Department of Energy
Carlsbad Field Office
P. O. Box 3090
Carlsbad, New Mexico 88221
September 29, 2017

Subject: Planned Change Notice Regarding the Excavation and Construction of a New Ventilation Shaft and Associated Access Drifts at the Waste Isolation Pilot Plant

New Shaft and Connecting Drifts
(Conceptual Drawings Only)

Impact Assessment of an Additional WIPP Shaft

PLANNED DRIFTS TO CONNECT THE NEW SHAFT TO THE REPOSITORY

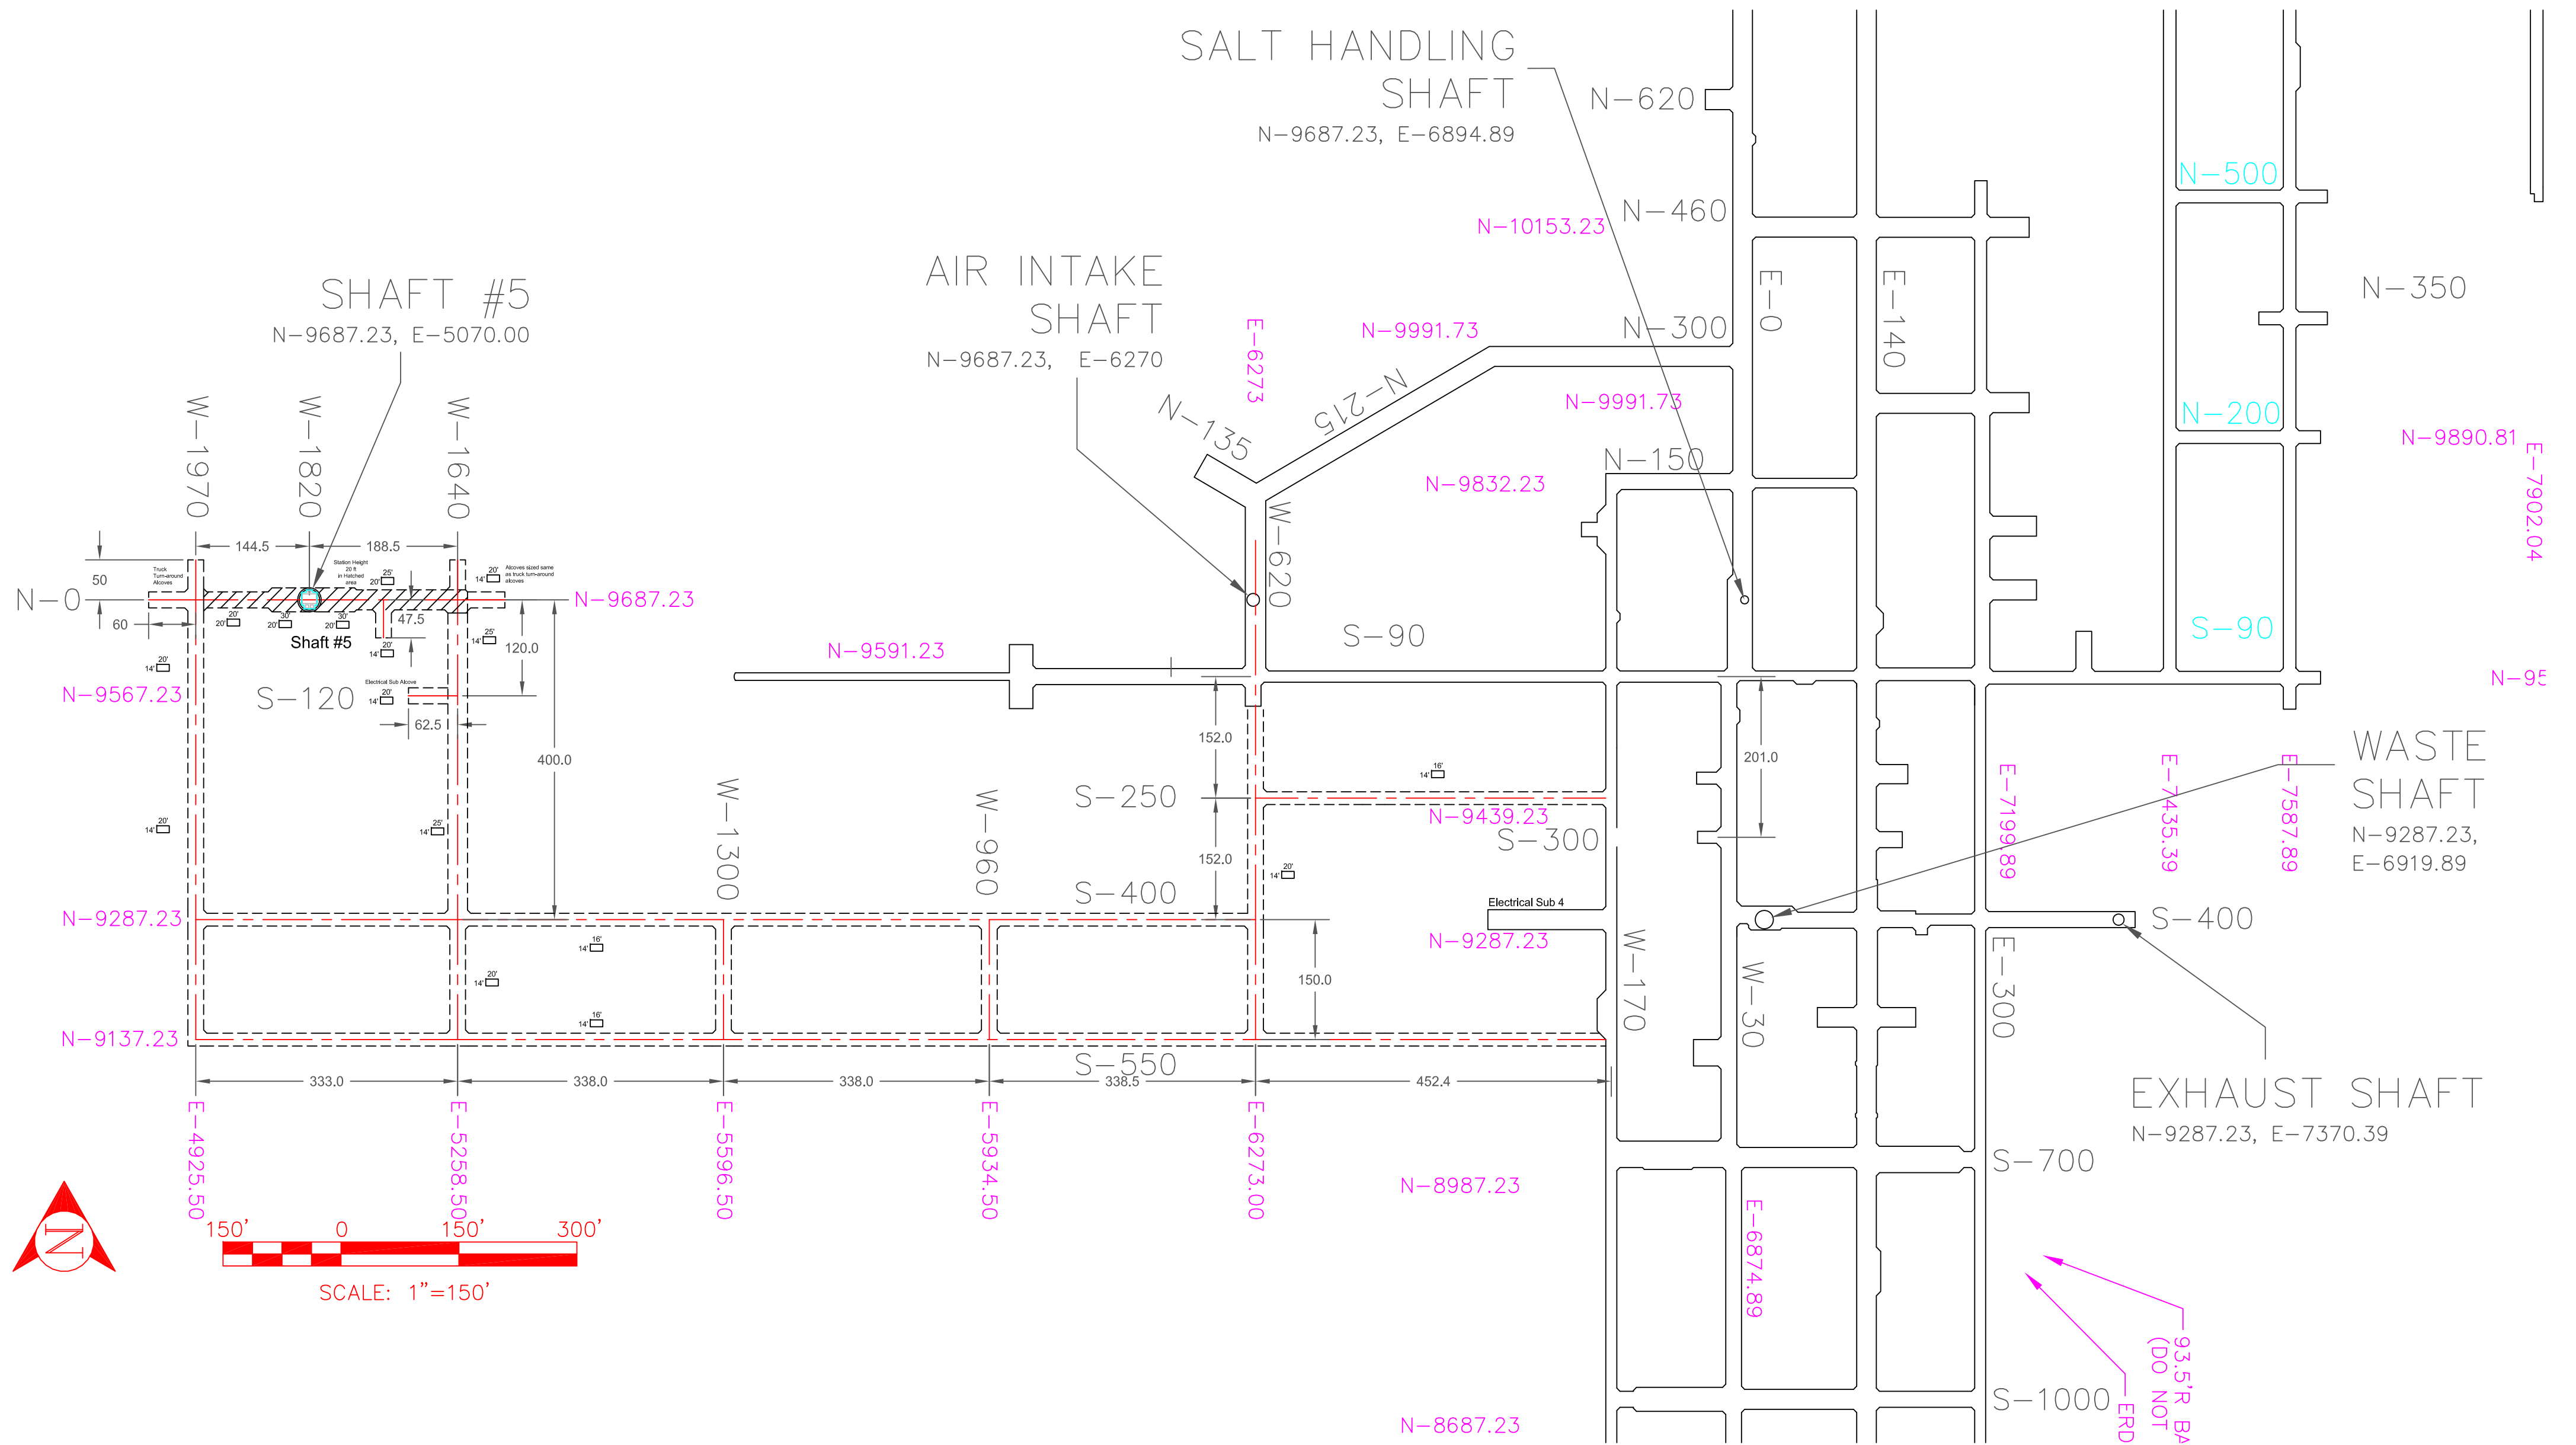
The purpose of this letter is to notify you of the plan to add a new ventilation shaft (shaft #5) and associated access drifts to the underground facility at the Waste Isolation Pilot Plant (WIPP). These changes are needed to provide additional ventilation in the underground facility.

Shaft #5 (S#5) will be located nominally 1,200 feet west of the existing Air Intake Shaft (AIS). Surface-mounted fans are planned for downcasting air into the underground via S#5. The air from S#5 will primarily be used to ventilate the Construction and Disposal Circuits through the new connecting drifts. Exhaust air, from the North, Disposal, and Waste Shaft Station Circuits, is planned to be exhausted through the existing Exhaust Shaft. Exhaust air from the Construction Circuit is planned to be routed through the existing AIS. Enclosure 1 depicts the surface location of S#5 and provides the conceptual drawings of S#5 and associated drifts. Excavation of the new shaft will occur to the northwest of the existing underground disposal area, approximately 1,970 feet from the West-170 access main and 2,000 feet from the nearest point in Panel 7. The new access drifts are located approximately 1,200 feet from the closest points in Panel 8.

Conceptual Drawing Only
 Dashed lines are proposed drifts
 Solid lines are existing drifts
 Dimensions are nominal

Figure 2-2: The BRAGFLO Repository Representation used in the Exhaust Shaft Impact Assessment

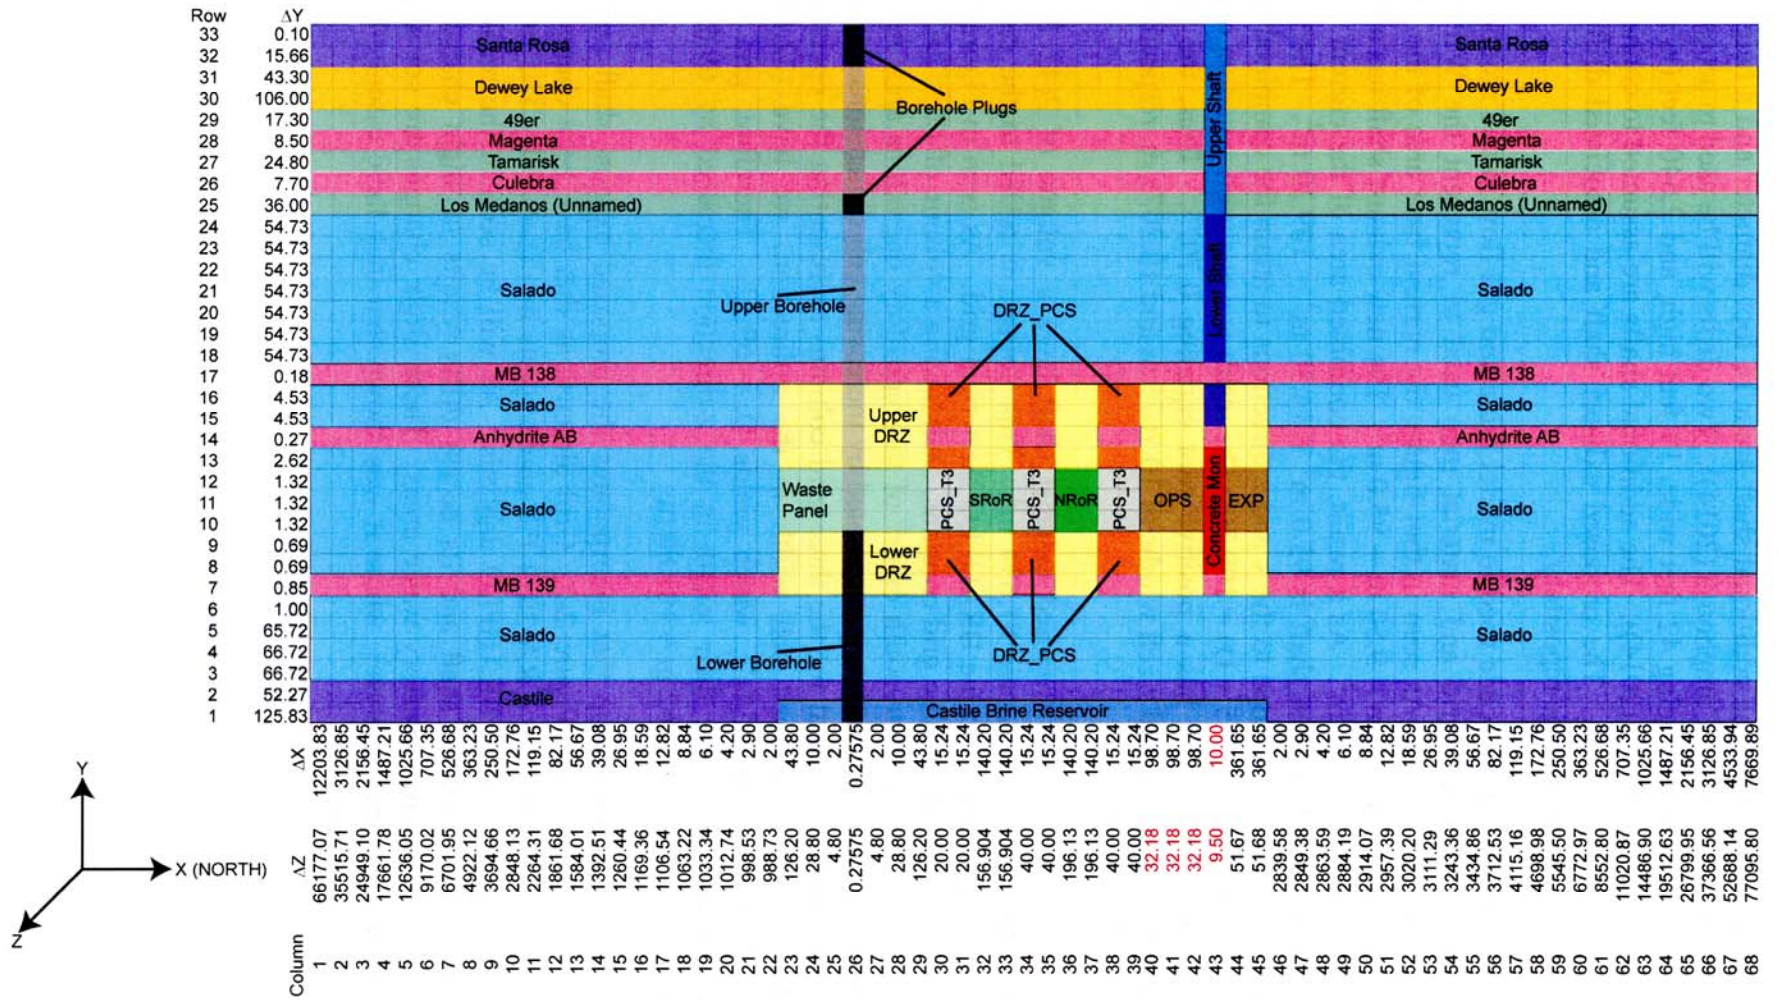
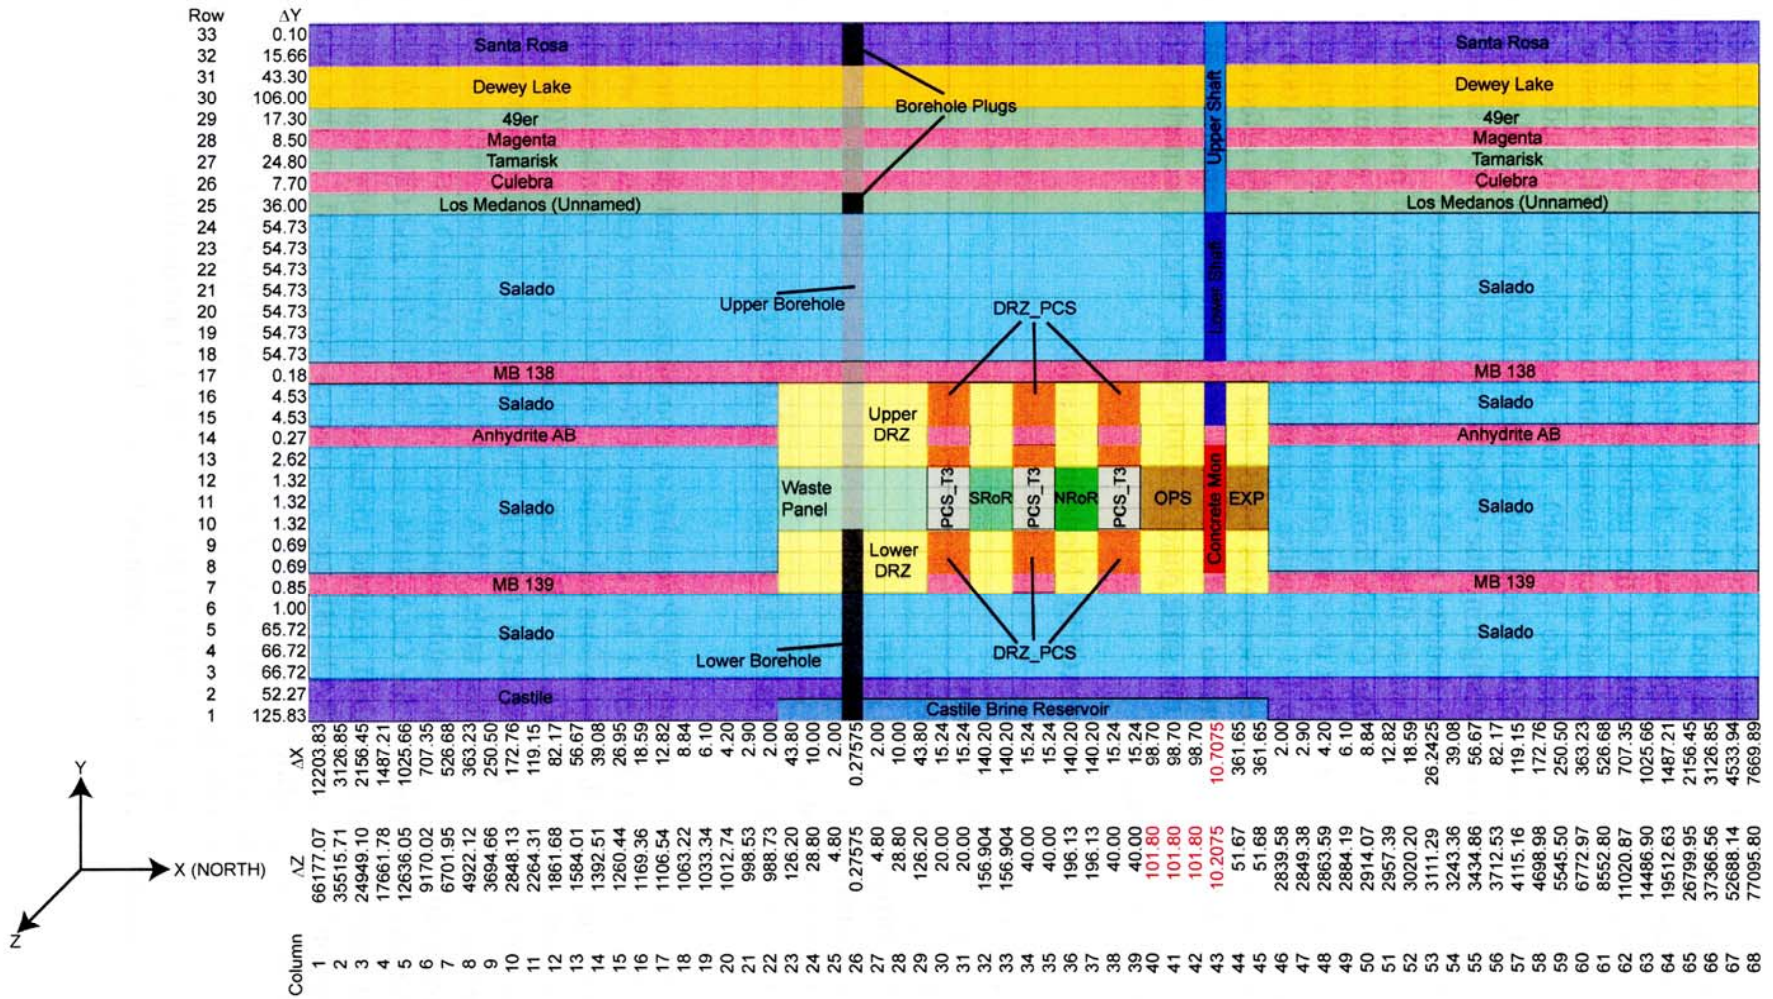
The code BRAGFLO is the WIPP PA code used to model brine and gas flow in and around the repository. The current numerical grid and material map used to represent the WIPP in BRAGFLO are shown in Figure 2-1. As seen in that figure, the current base area of the shaft representation in BRAGFLO is $10.00 \text{ m} \times 9.50 \text{ m} = 95.0 \text{ m}^2$. The new exhaust shaft has a base area of $\pi (7 \text{ ft})^2 = 153.94 \text{ ft}^2 = 14.30 \text{ m}^2$. As a result, the combined area of the current shaft representation and the proposed exhaust shaft is $95.0 \text{ m}^2 + 14.30 \text{ m}^2 = 109.30 \text{ m}^2$. The same increase in length, denoted by D, is added to the x and z directions to attain the combined base area of all five shafts, i.e. $(10.0 + D)(9.5 + D) = 109.30$. The result is a quadratic equation of the form $D^2 + 19.5D - 14.3 = 0$, which has a positive root equaling 0.7075. Thus, the shaft representation is modified to have x and z cell widths of 10.7075 m and 10.2075 m, respectively, for the analysis undertaken herein.

The two drifts corresponding to the proposed exhaust shaft have a volume of $2(42 \text{ ft})(13 \text{ ft})(2,640 \text{ ft}) = 2,882,880 \text{ ft}^3$, which equals $81,634 \text{ m}^3$. This volume is added to the current representation of the operations area in the BRAGFLO numerical grid. As seen in Figure 2-1, the operations area is represented by three grid columns, each having a volume of $12,577.62 \text{ m}^3$. The new drifts do not alter the north-to-south extent of the repository operations area, nor its height. As a result, the increased volume is incorporated by increasing cell dimensions in the z-direction, with the increase being equal for the three grid columns representing the operations area. With D denoting the increased cell width in the z-direction, we have $(32.18 + D)(98.70)(3.96) = 12,577.62 + (81,634)/3$, which yields $D = 69.62$. Therefore, grid cells representing the operations area have their length in the z-direction increased by 69.62 m, yielding a total length of $32.18 \text{ m} + 69.62 \text{ m} = 101.80 \text{ m}$.

The BRAGFLO grid and material map that incorporates the proposed exhaust shaft and its associated access drifts are shown in Figure 2-2. Grid dimensions that have been changed in Figure 2-2 are in red font, as are their CRA-2014 PA counterparts in Figure 2-1. The impact assessment done herein consists of a BRAGFLO analysis. As will be seen in the results to follow, the addition of the proposed shaft and its access drifts results in slight changes to pressures and brine saturations in repository waste areas. These slight changes are not unlike those that have been seen in prior analyses, where it was shown that they have essentially no impact on regulatory compliance.
